ADDENDUM NO. 1
November 11, 2025

PROJECT: BITTER CREEK WSC
NEW WATER WELL

BITTER CREEK WATER SUPPLY CORPORATION
WATER WELL ADDITION (WELL #7)

WELL DETAILS

WELL SECTION
NTS

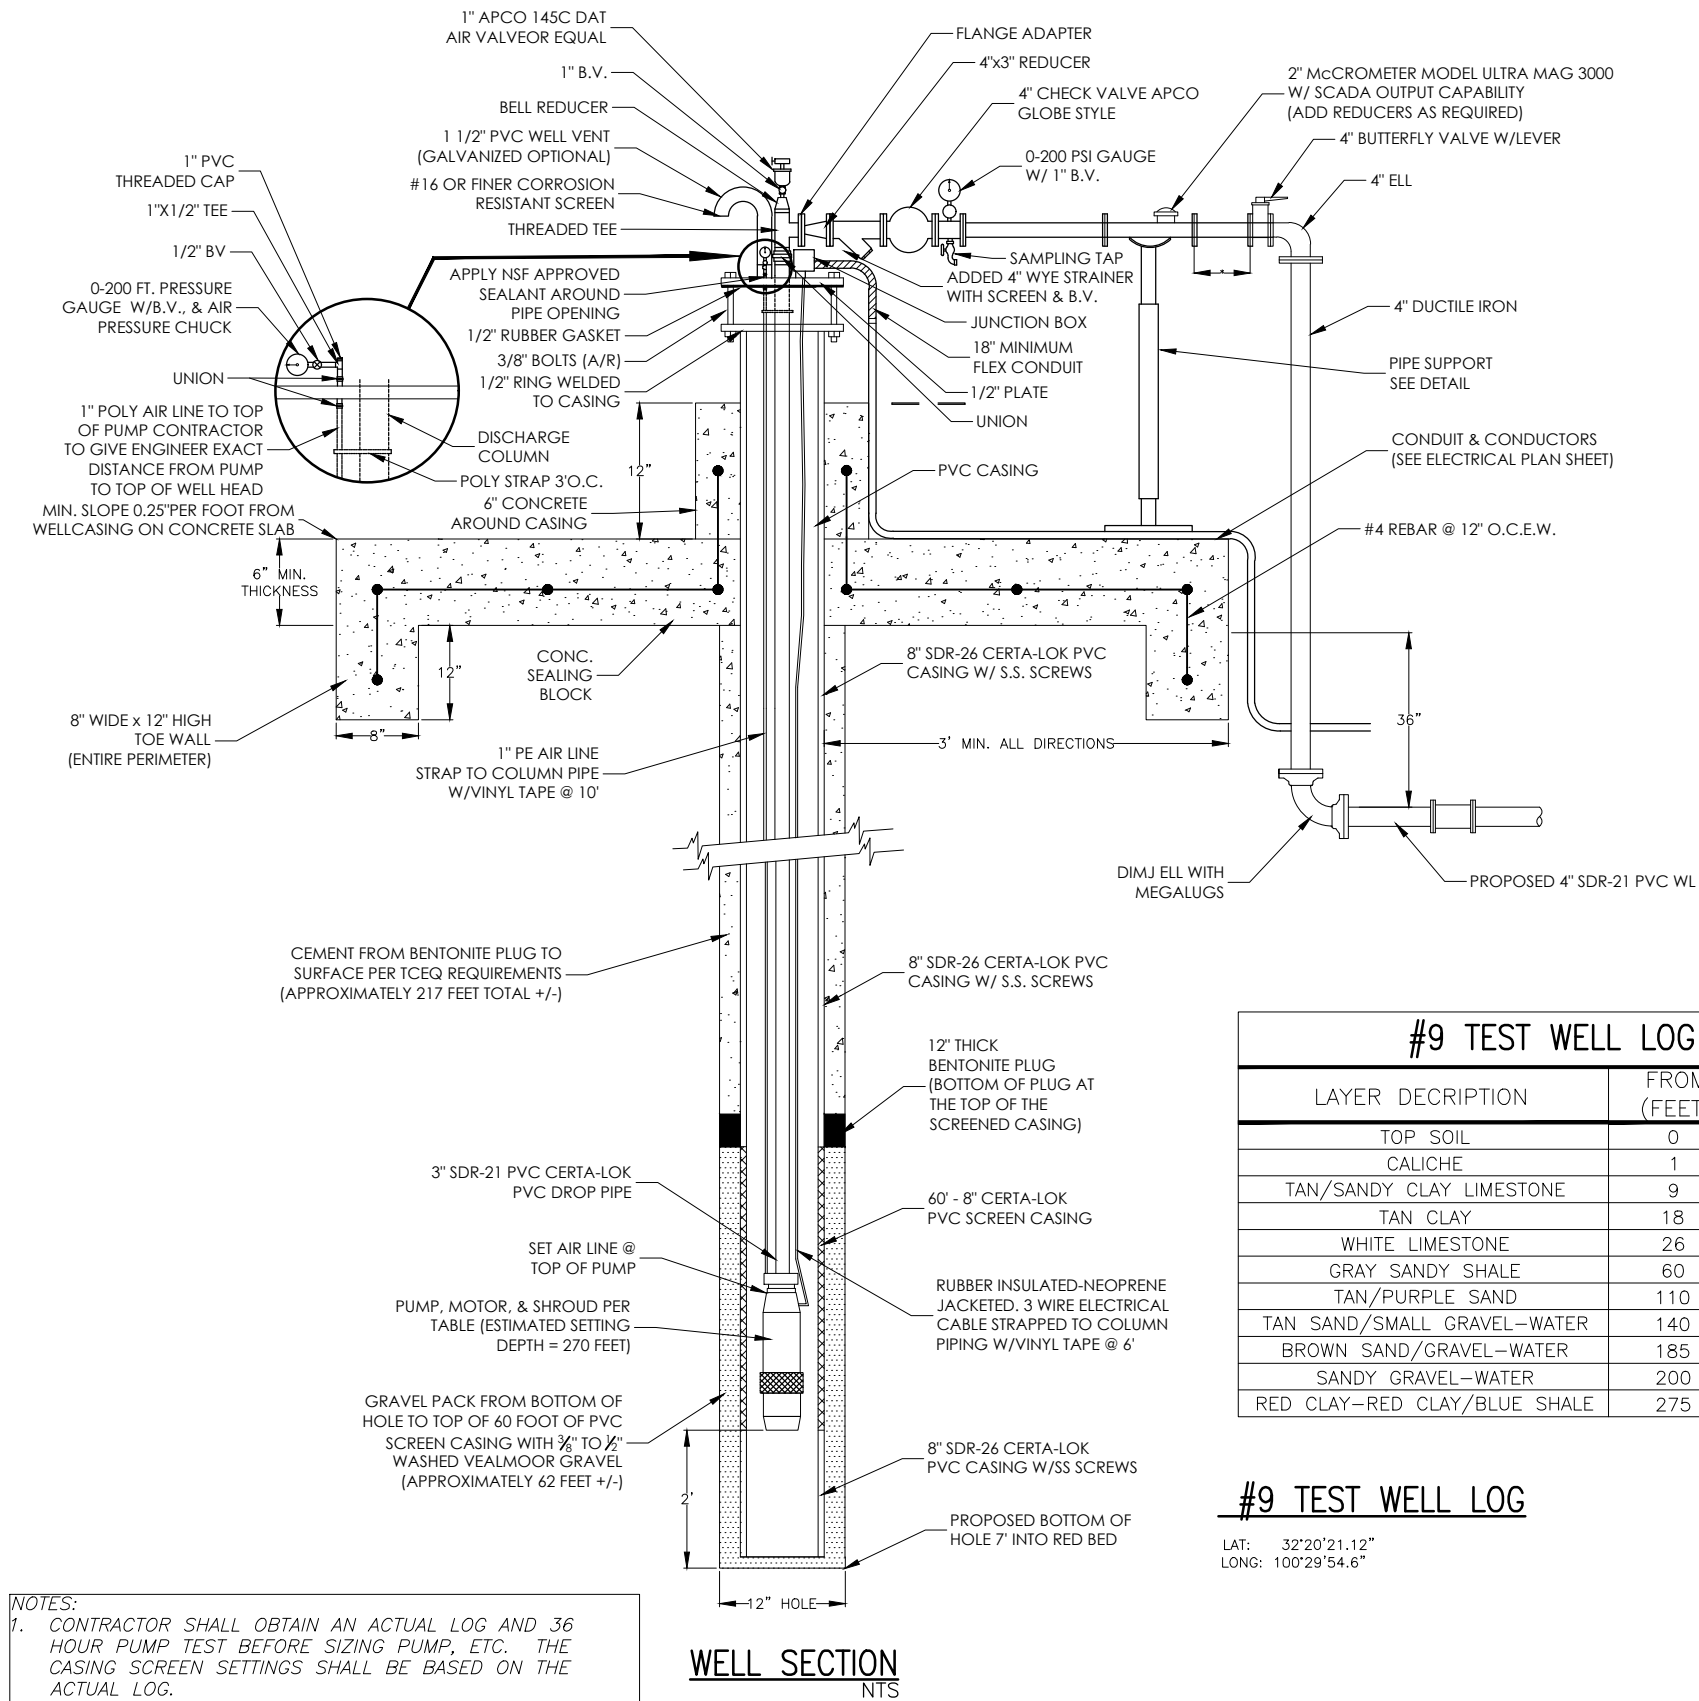
- a) The attached plan sheet 4 shall replace the existing plan sheet 4.
 - i) The PVC screen casing has been extended from 20 feet to a total of 60 feet.
 - ii) The proposed well will be gravel packed from the top of the 60 foot screened casing down to the bottom of the hole.
 - iii) The bentonite plug will be installed at the top of the screened casing and then the well will be cemented from the bentonite plug to the surface.
